TO: Rick Knowland, Senior Planner  
FROM: William J. Bray, Traffic Engineer  
SUBJECT: Donbury Offices Site Plan

PLANNING REPORT #56-87

DONBURY SUBDIVISION AND SITE PLAN REVIEW

SUBJECT: Donbury Site Plan and Subdivision - Canco Road

DRAINAGE AREA SKETCH  
N.T.S.

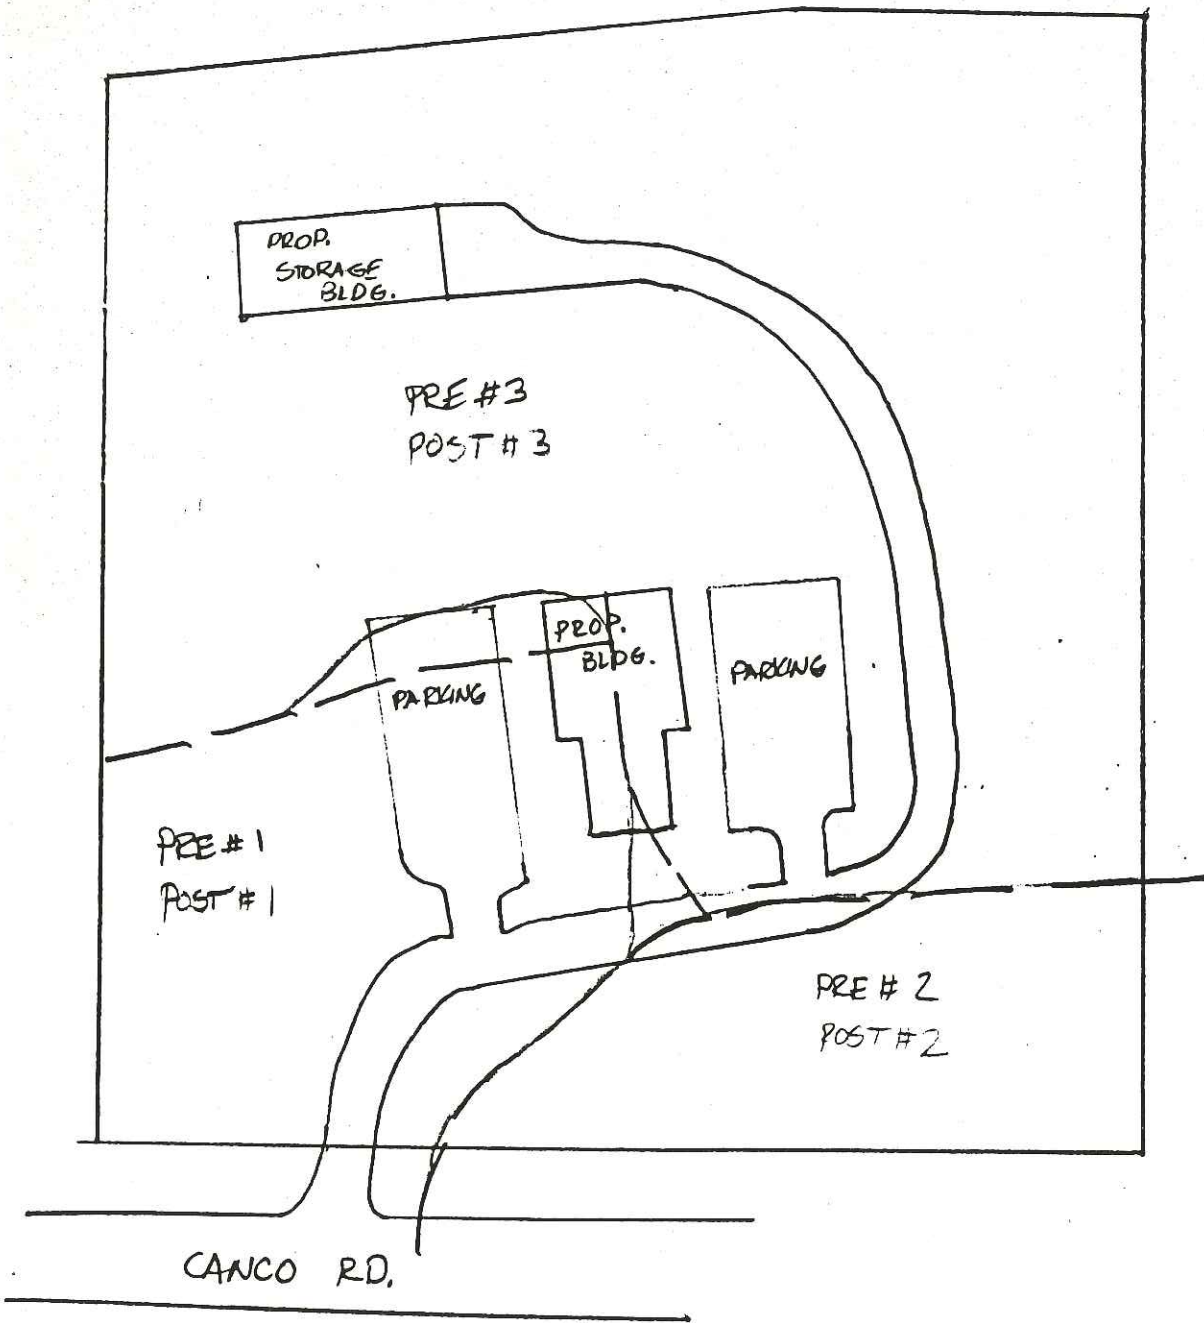
This letter provides supplemental information for the Stormwater Management Analysis on Donbury Offices of June 9, 1987. A clarification of where water flows in Drainage Basin #3 was requested.

Under existing conditions, runoff from the proposed Donbury site sheets from the high point on the site toward the rear. After going off site, the runoff enters either a small retention pond or sheets across an existing gravel path into a large swampy area. It is also evident that when and if the pond fills with water, it spills across this same gravel path and into the wet area.

Under post-development conditions, the path of the runoff will be the same. Development will not alter the water course. Runoff will flow to the retention pond and the wet area as it did under pre-development conditions. Also, we would like to reiterate that the pre-/post-development peak discharge from this drainage basin will be nearly the same (2 year storm 4.23 c.f.s pre, 4.28 c.f.s. post; 25 year storm 12.1 c.f.s. pre, 12.25 c.f.s. post). The difference in flows is negligible.
